ADDENDUM 3

DATE: November 18, 2016
PROJECT: MSB First Floor Infill LRC 3 & 4
RFP NO: 744-R1705
OWNER: The University of Texas Health Science Center at Houston
TO: Prospective Proposers

This Addendum forms part of and modifies Proposal Documents dated, October 19, 2016, with amendments and additions noted below.

Electrical Lighting Demolition and Alteration Plans First Floor East

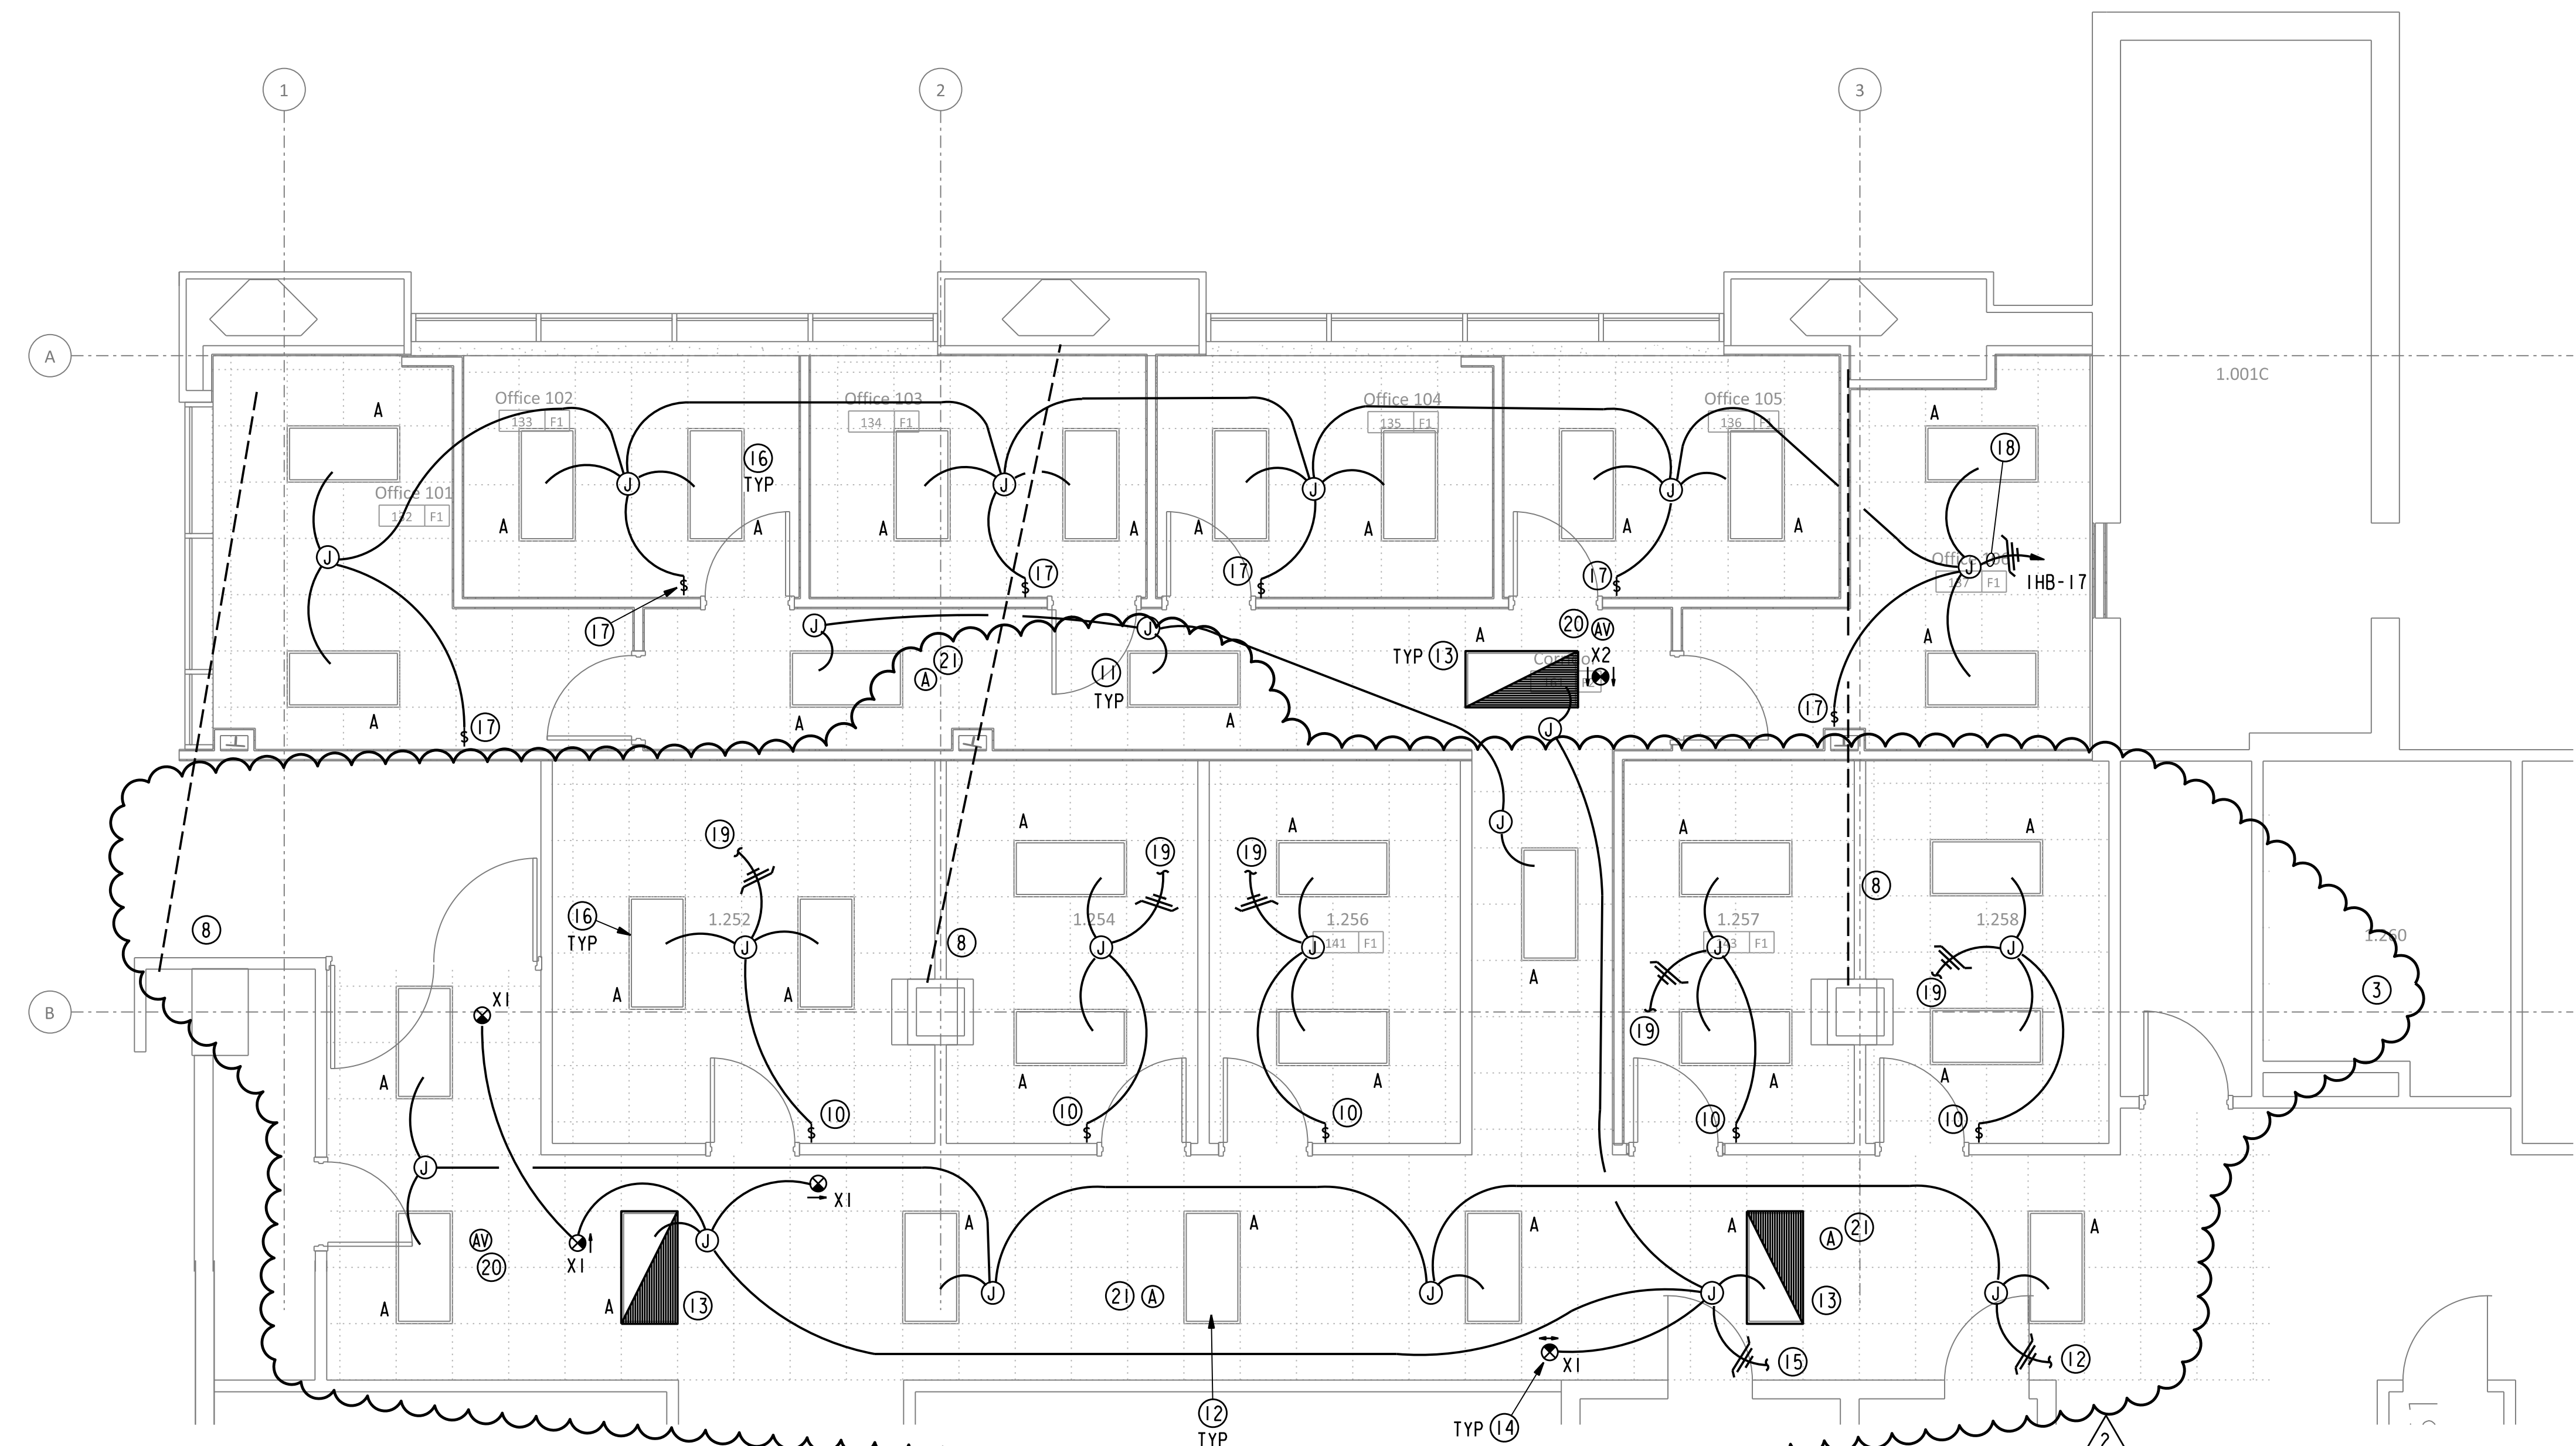
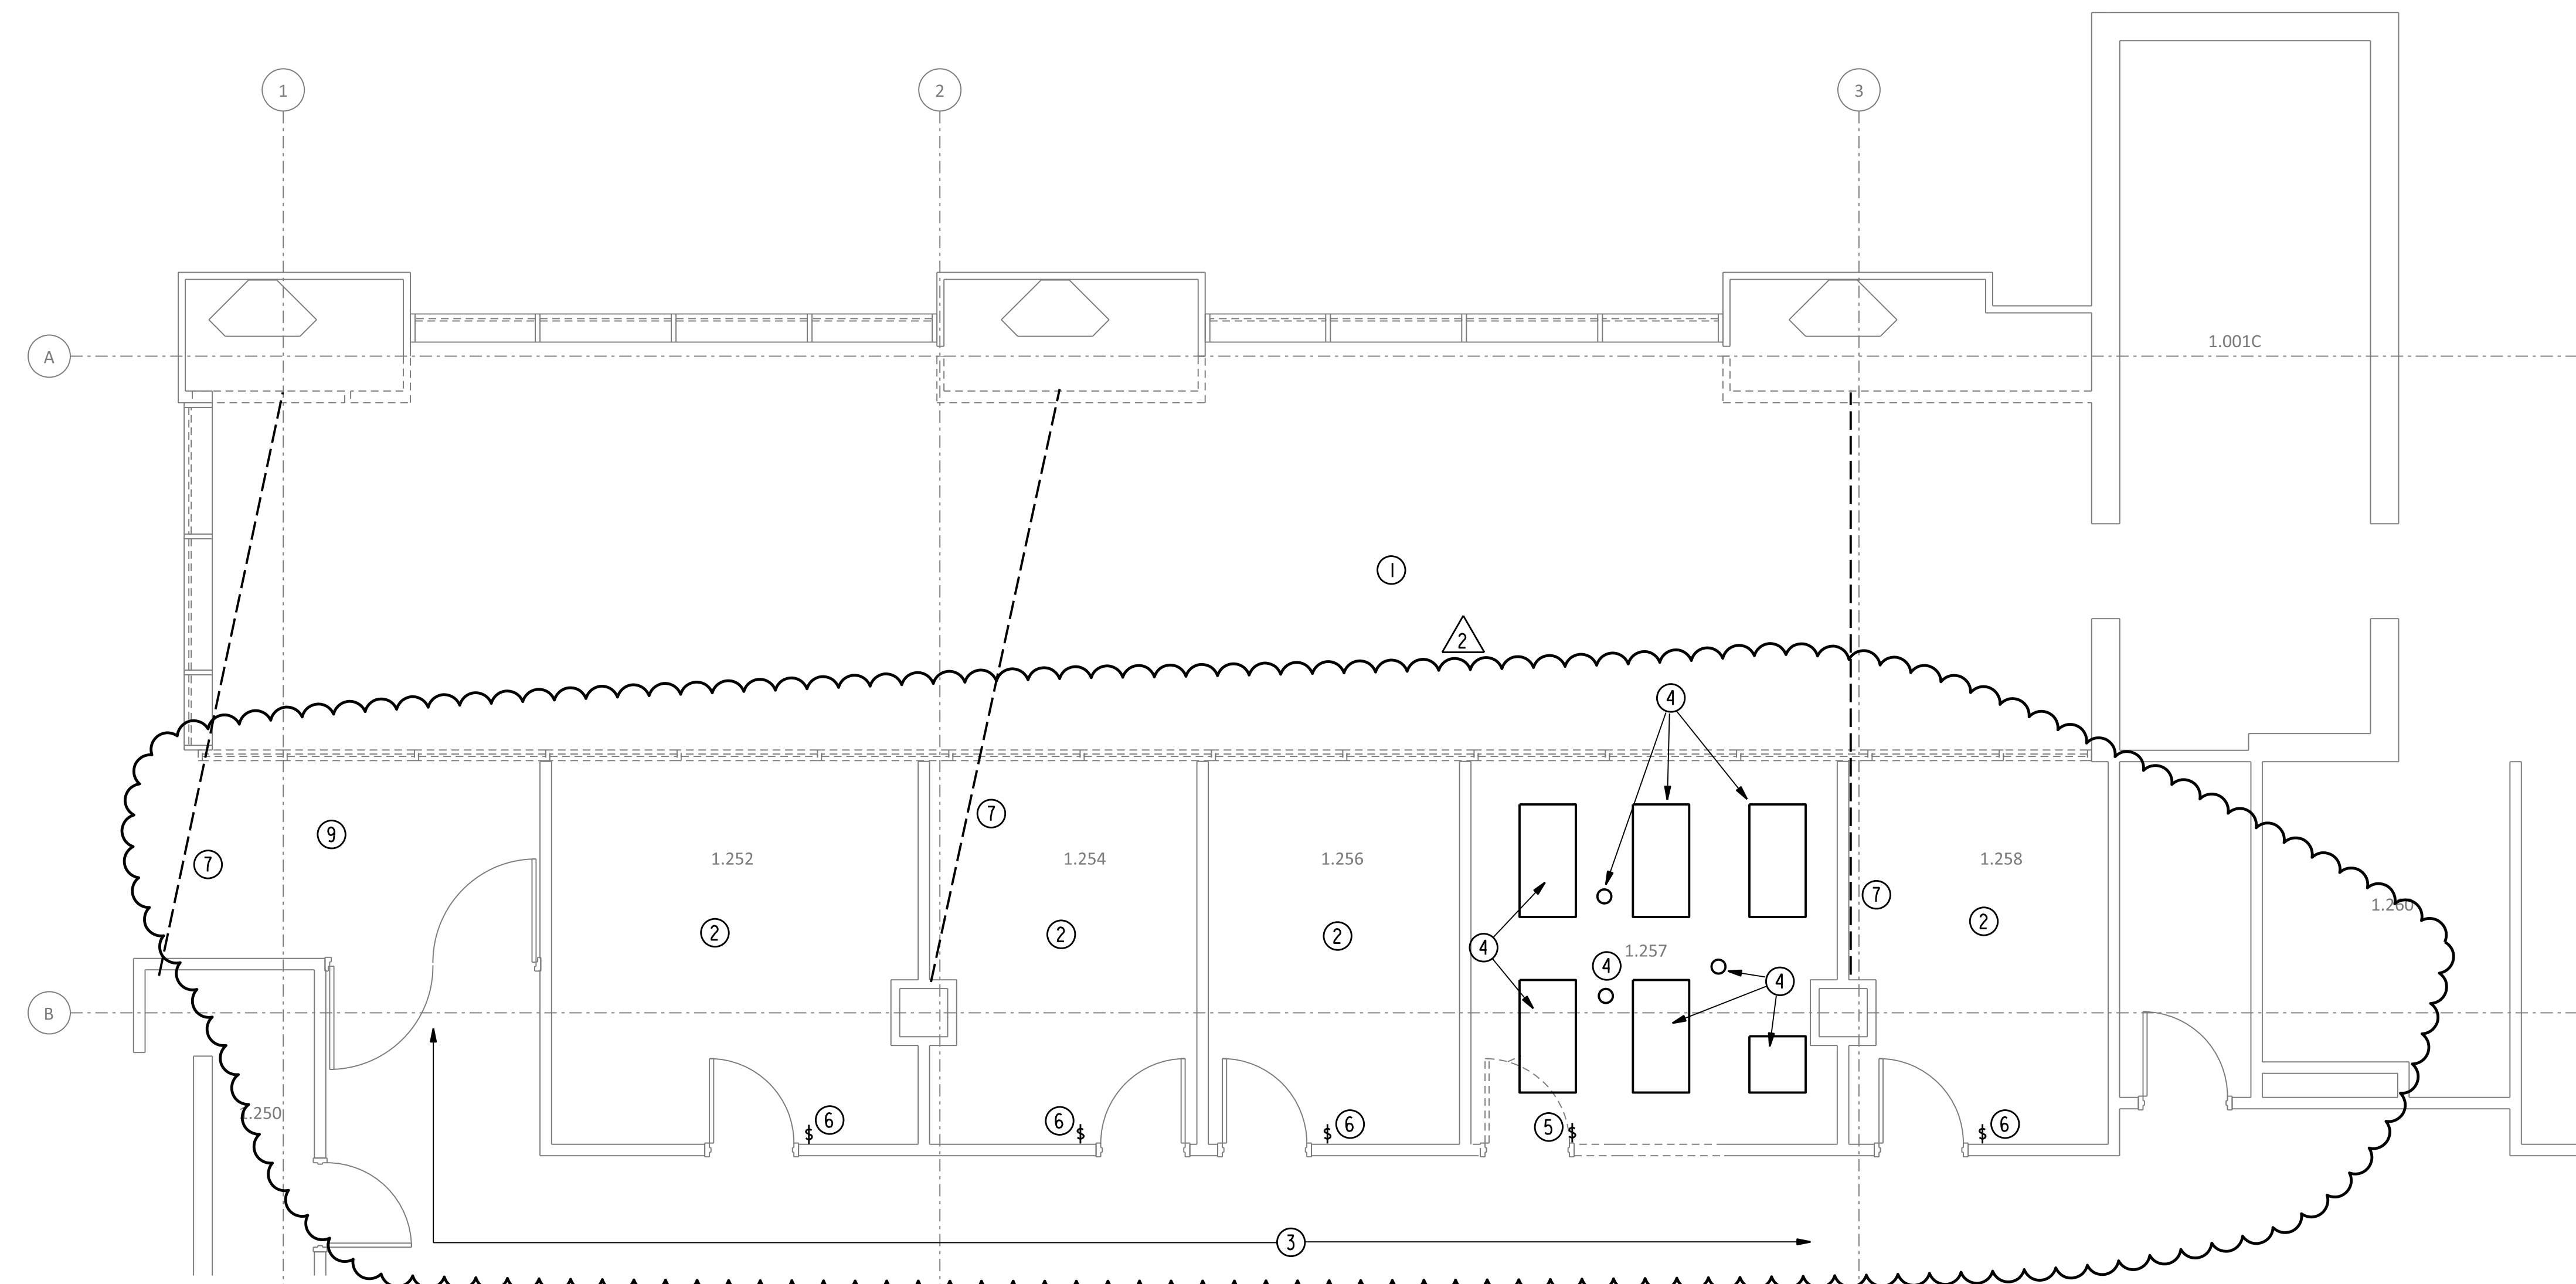
- a. Drawing note #16 on sheet EL1.01AE, "NEW BASE BID 2 X 4 FLUORESCENT LIGHT FIXTURE, TYPE AS NOTED. PROVIDE ALTERNATE TYPE A LED LIGHT FIXTURES FOR ALTERNATE 1." (Alternate 1 turns a large portion of the new Type A light fixtures to Type A LED light fixtures)

- a. Drawing note #2 on sheet EL1.01AE, "FOR BASE BID EXISTING LIGHTING AND ASSOCIATED LIGHTING CONTROLS AND BRANCH CIRCUIT WIRING IN THIS ROOM TO REMAIN AND BE REUSED. REMOVE AND REINSTALL LIGHT FIXTURES AS REQUIRED TO INSTALL NEW HVAC TERMINAL UNITS AND DUCTWORK. RE: DEL1.01A AND EL1.01 FOR ALTERNATE 2 LIGHT FIXTURE AND LIGHTING CONTROL REPLACEMENT IN THIS ROOM.
- b. Drawing note #3 on sheet EL1.01AE, "FOR BASE BID EXISTING LIGHTING AND ASSOCIATED LIGHTING CONTROLS AND BRANCH CIRCUIT WIRING IN THIS ROOM TO REMAIN AND BE REUSED. RE: DEL1.01A AND EL1.01 FOR ALTERNATE 2 LIGHT FIXTURE AND LIGHTING CONTROL REPLACEMENT IN THIS ROOM.
- c. Drawing note #9 on sheet EL1.01AE, "FOR BASE BID, INSTALL FLUORESCENT LIGHT FIXTURES, TYPE AS NOTED, IN THIS ROOM.

Print Date / Time: 11/15/2016 2:46:12 PM
P&W Commission Number: 3339.00
Sheet Number: EP1.01A

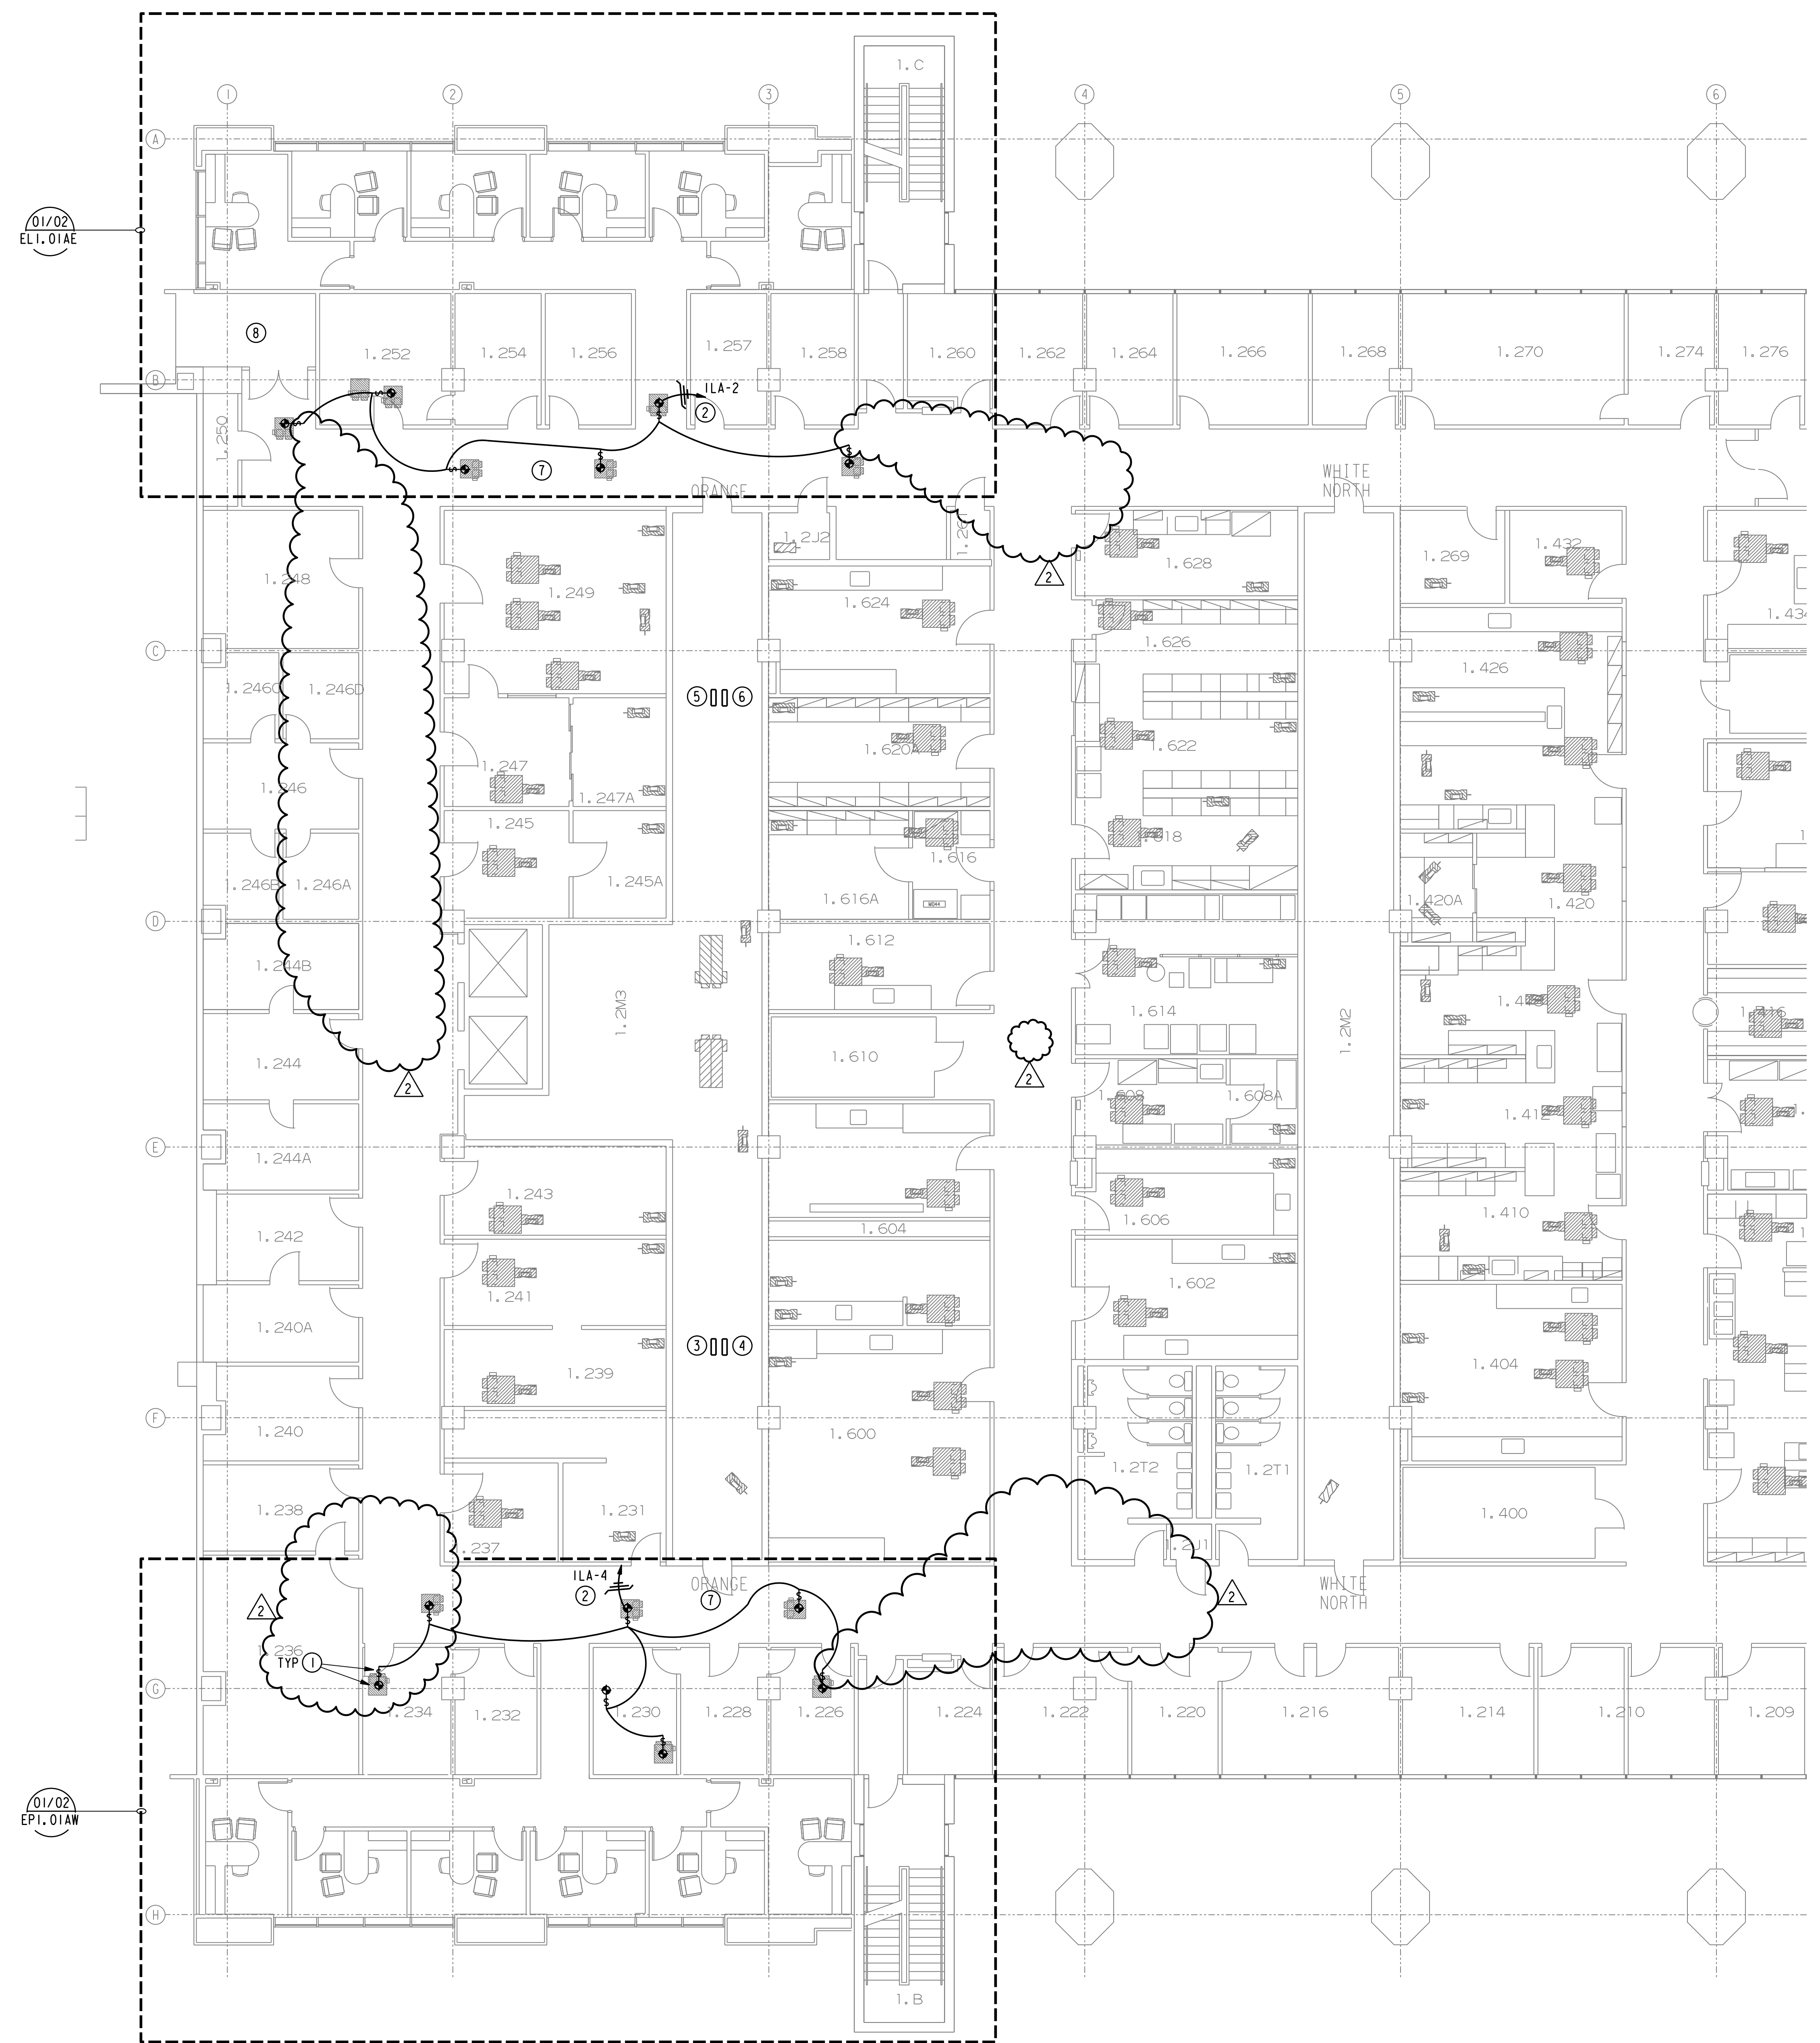
c. Drawing note #7 on sheet EP1.01A, "BASE BID, REMOVE AND REINSTALL EXISTING CEILING MOUNTED ELECTRICAL DEVICES IN CORRIDOR AS REQUIRED TO ALLOW NEW HVAC TERMINAL UNITS AND RELATED DUCTWORK, CONTROL WIRING AND CONTROL POWER TO BE INSTALLED. ALTERNATE 3, REMOVE ALL EXISTING CEILING MOUNTED ELECTRICAL DEVICES FOR CORRIDOR CEILING REPLACEMENT AND REINSTALL IN NEW CORRIDOR CEILING.
